Safety Evaluation Report (Revised)
for the Dewey-Burdock Project
Fall River and Custer Counties,
South Dakota

Materials License No. SUA-1600

Docket No. 40-9075
Powertech (USA) Inc.

U.S. Nuclear Regulatory Commission

Figure 2.3-3: Dewey-Burdock Project Site Geologic Map

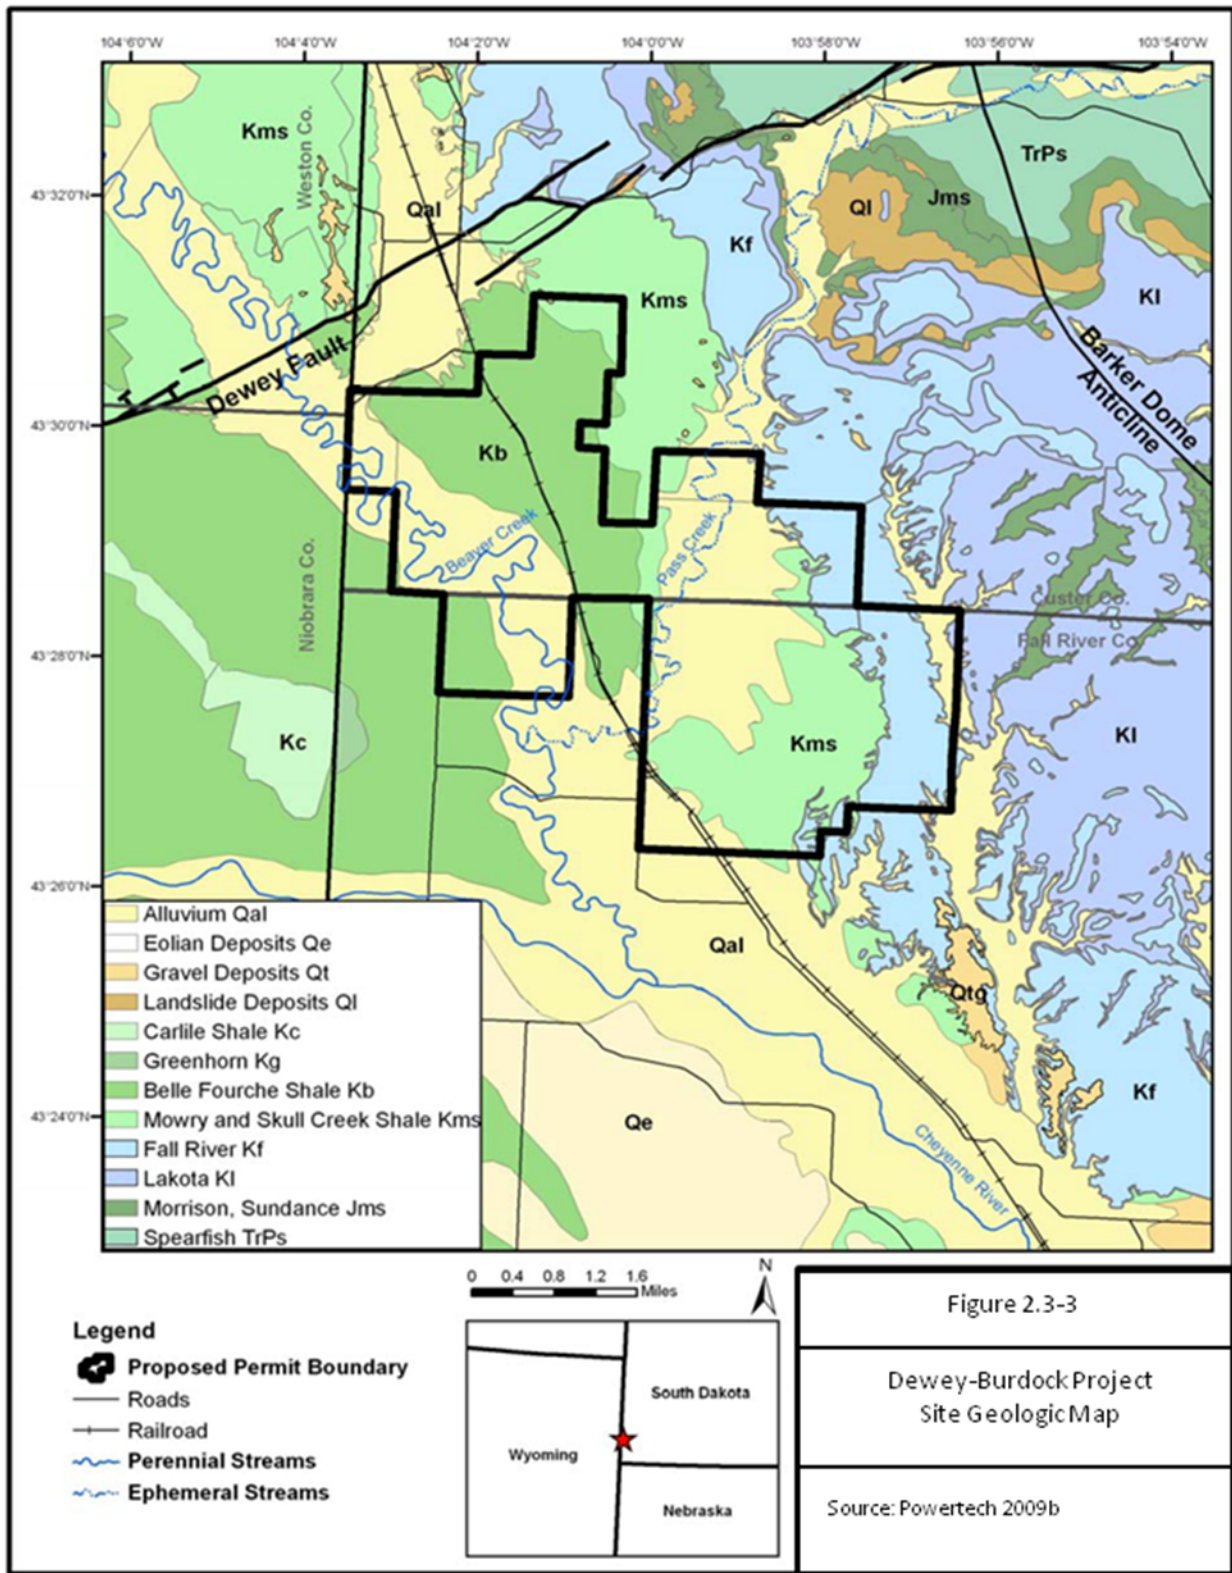
The applicant provided a description of the site geology based on site data and outside information. Application Figure 2.6-2 presents the Dewey-Burdock Project surficial geology, which is reproduced as SER Figure 2.3-3 (Powertech, 2009c). The applicant states that the Fall River Formation outcrops across the eastern part of the project and the Skull Creek Shale and Mowry Shale outcrop across the western part of the project (Powertech, 2009c). Alluvium is present along drainage areas, such as Beaver Creek and Pass Creek (Powertech, 2009c). The staff observes that the application does not discuss the presence of the Belle Fourche Shale, which outcrops on the surface of the Dewey area of the Dewey-Burdock Project. However, a published South Dakota geologic map clearly identifies the Belle Fourche Shale in the Dewey area of this project (James E. Martin, J. F. S., Mark D. Fahrenbach, Dennis Tomhave, and Layne D. Schulz, 2004).

Figure 3.1-1: Madison Aquifer Drawdown – Edgemont Pumping

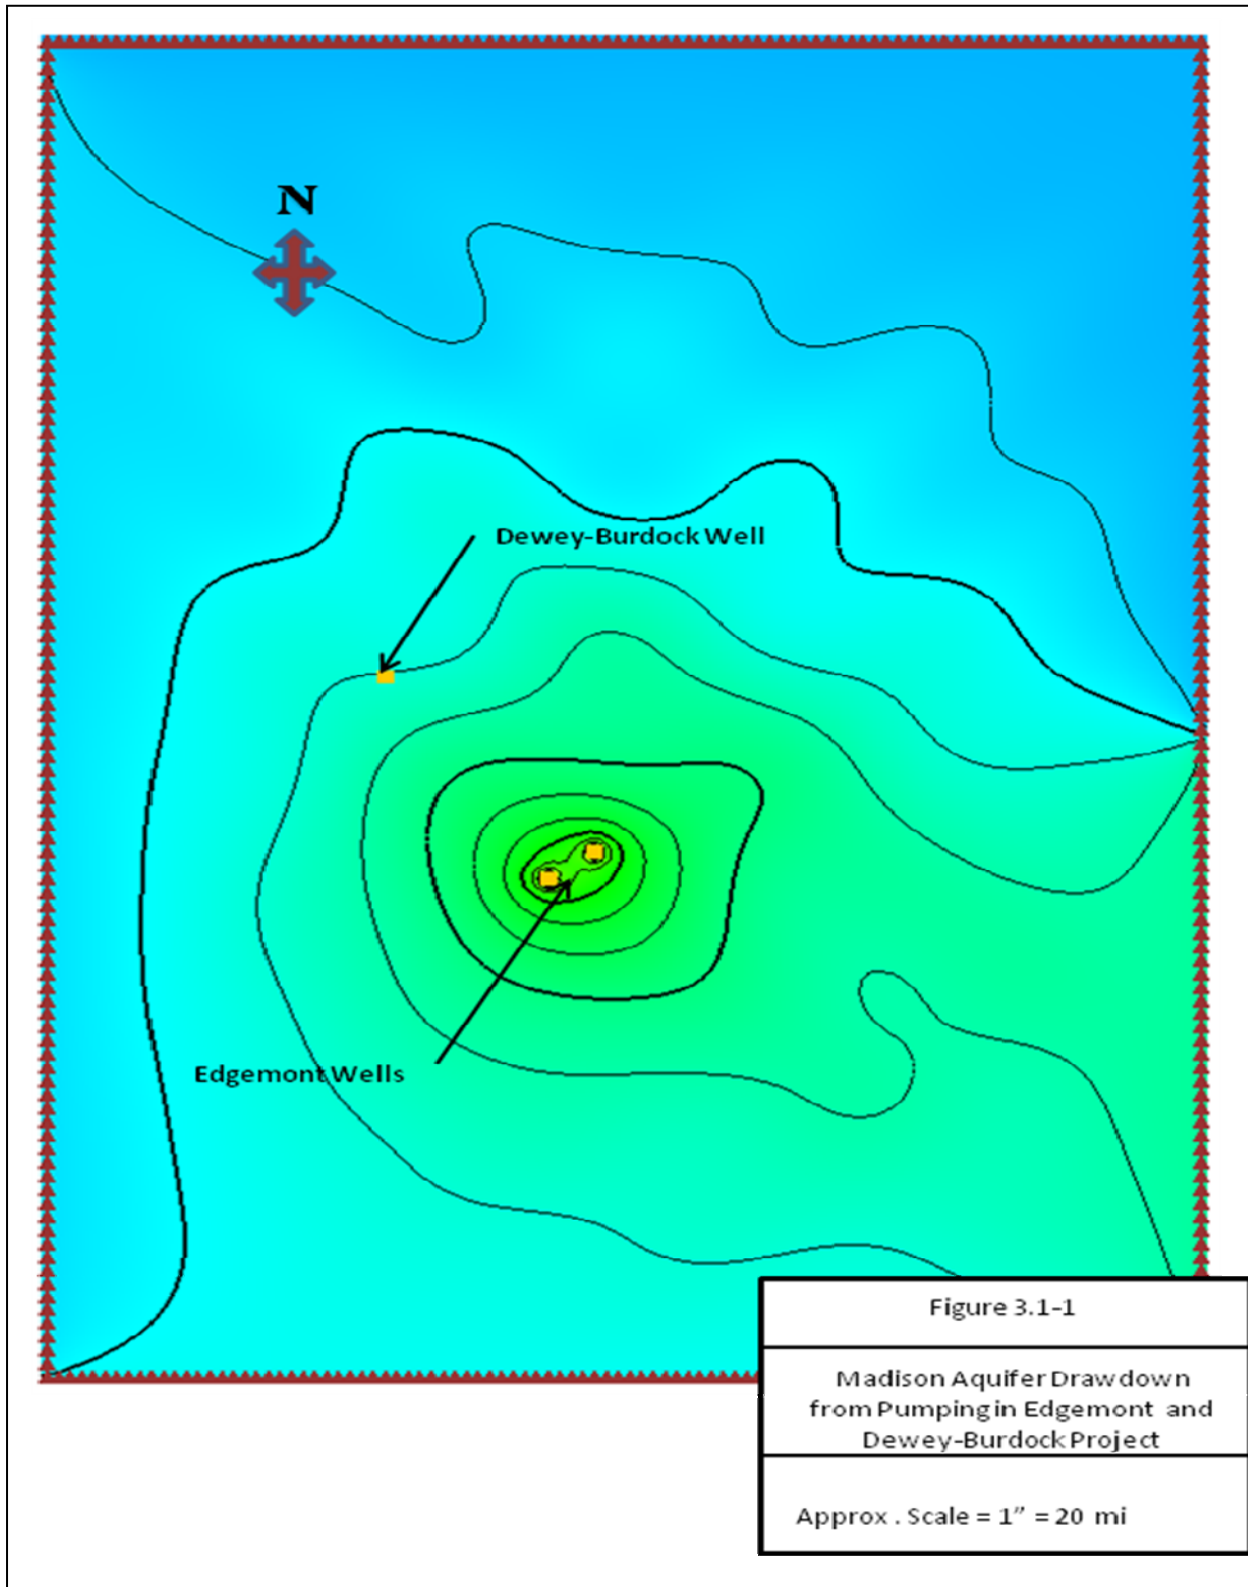
groundwater withdrawals. Water withdrawal rates in the City of Edgemont were obtained from water rights issued by the State of South Dakota and are publicly available on the SD DENR website (SD DENR, 2012). Results of the analysis indicate the Edgemont wells would produce a large cone of depression that encompasses the Dewey-Burdock Project, if these wells operated constantly (conservative assumption) (SER Figure 3.1-1). When the Dewey-Burdock well is operating full-time (conservative assumption), the Dewey-Burdock well superimposes its cone of depression onto the Edgemont wells (SER Figure 3.1-2). However, based on the staff's review of the steady-state potentiometric surface maps and Madison Aquifer drawdown the drawdown induced by constant pumping of the Dewey-Burdock well does not appear to affect the operation of the Edgemont wells. Therefore, the proposed maximum Madison withdrawals at the Dewey-Burdock project do not appear to affect water supplies in the City of Edgemont, South Dakota.
